ACTION TRANSMITTAL

DATE: May 6, 2014
TO: Funding & Programming Committee
PREPARED BY: Carl Ohrn, Planning Analyst 651-602-1719
SUBJECT: Scope Change for Hwy 61 and Hwy 97 Reconstruction and Roundabout
REQUESTED ACTION: MnDOT requests a scope change to modify the scope of SP 8206-45 to eliminate one grade-separated pedestrian crossing and add various pedestrian facilities. The total project costs increase to \$7,082,697 with \$5,376,000 federal Surface Transportation Program (STP) funding and \$1,744,000 MnDOT and other funding in 2016.
RECOMMENDED MOTION: Recommend approval of the request to modify the scope and project cost for Hwy 61 and Hwy 97 project described above.

RE: SP 8206-45 Hwy 61 & Hwy 97 Reconstruction and Roundabouts – Scope Change Request

(4) HYBRID GRADE SEPARATED AND AT-GRADE ALTERNATIVE
 SUBJECT TO CHANGE 05-01-14

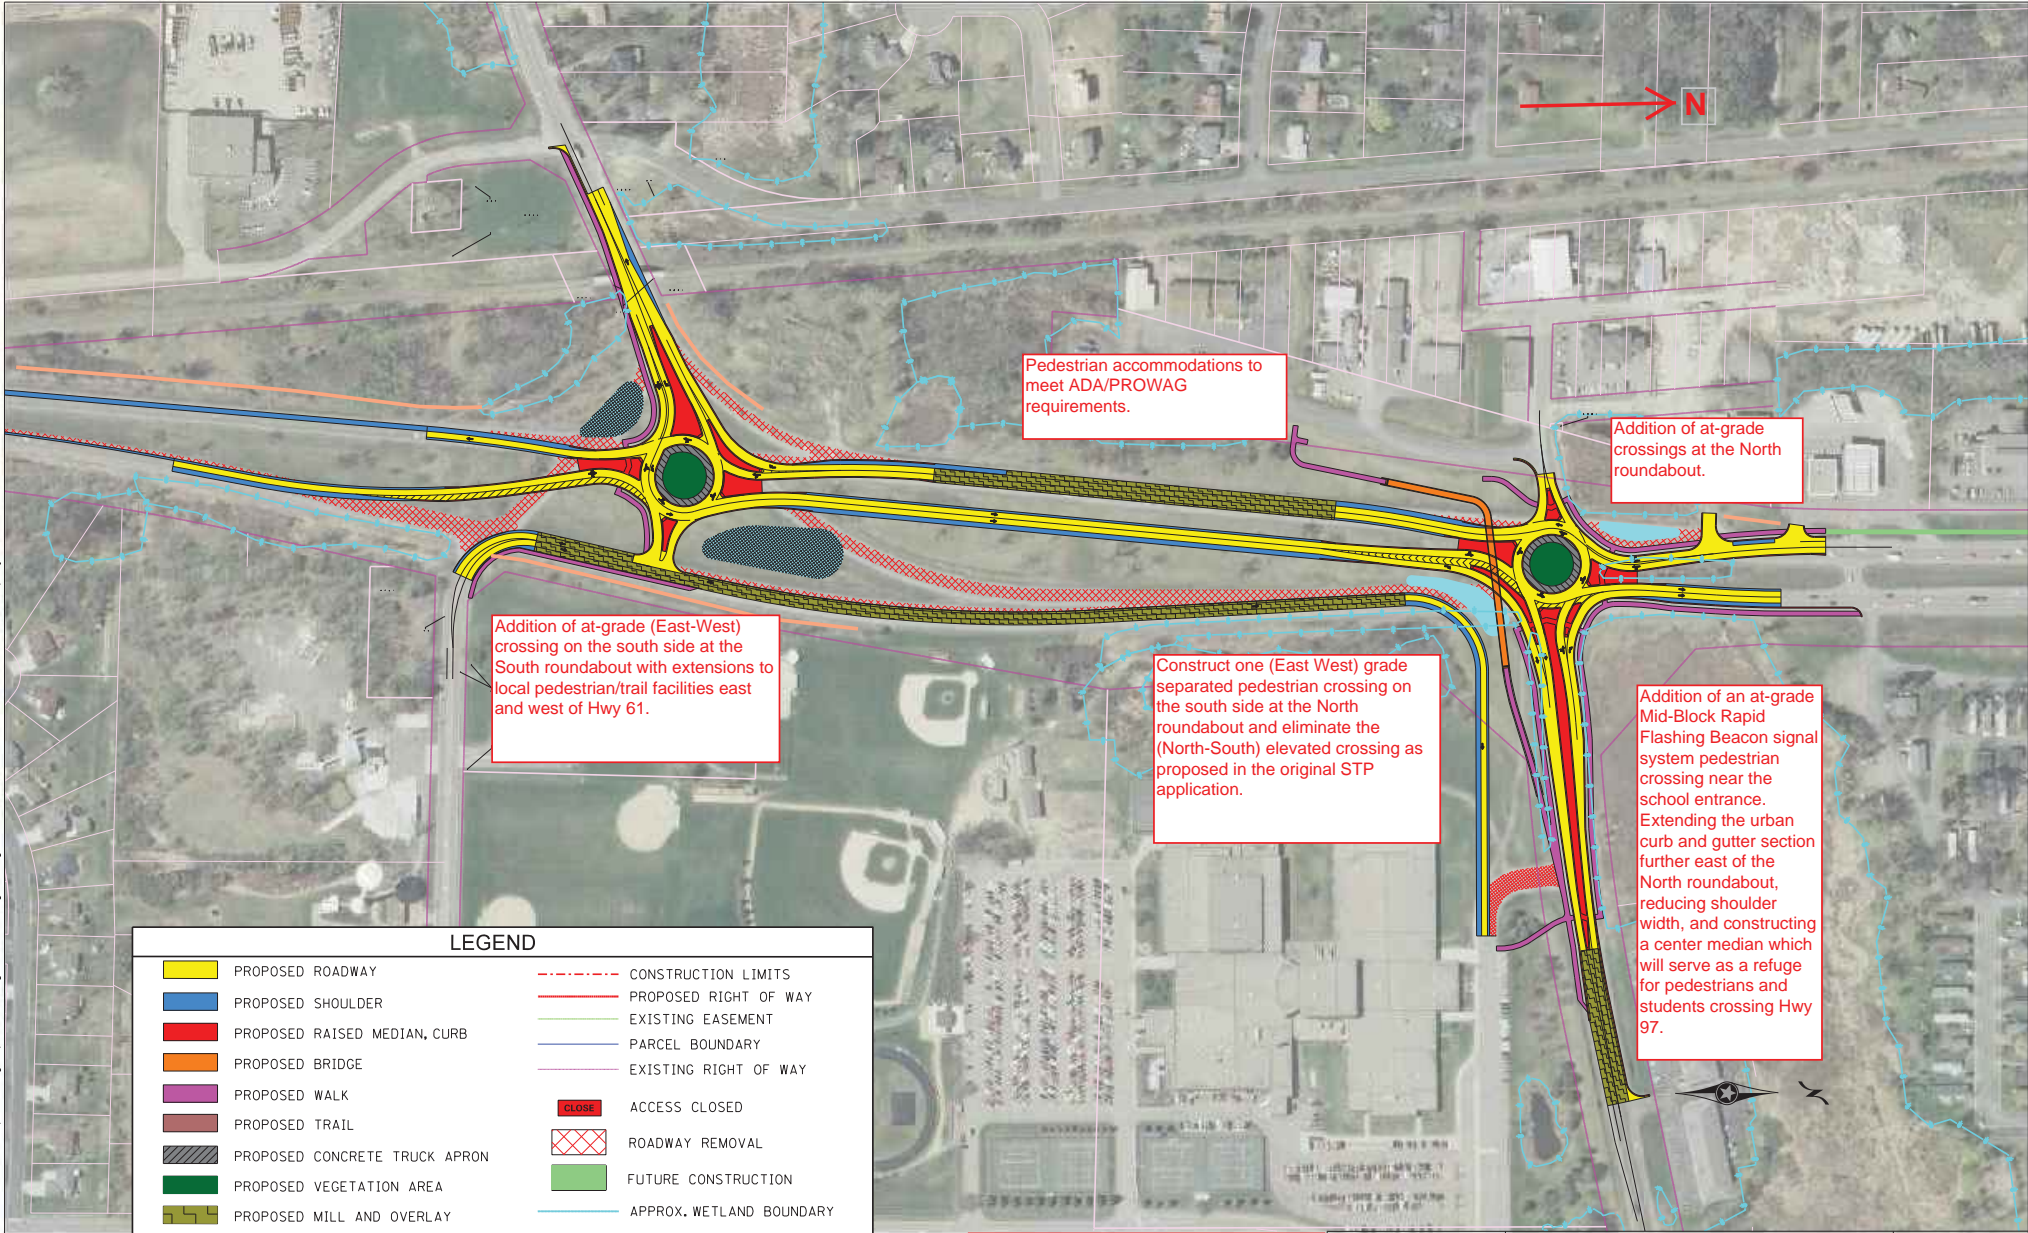
The proposed project includes **two grade seperated pedestrian crossings** at the northern junction of TH 97 and TH 61, new shared use paths to connect to existing trails and planned shared use facilities. The two grade seperated crossings will complete the connection between the Hardwood Creek Trail and residential areas west of TH 61 as well as residential areas north of TH 97 to the High and Middle Schools. As part of the project, shared use paths will connect to pedestrian improvements that the City of Forest Lake is proposing that will be adjacent to TH 61 in the downtown area as indicated in their Capital Improvement Plan.
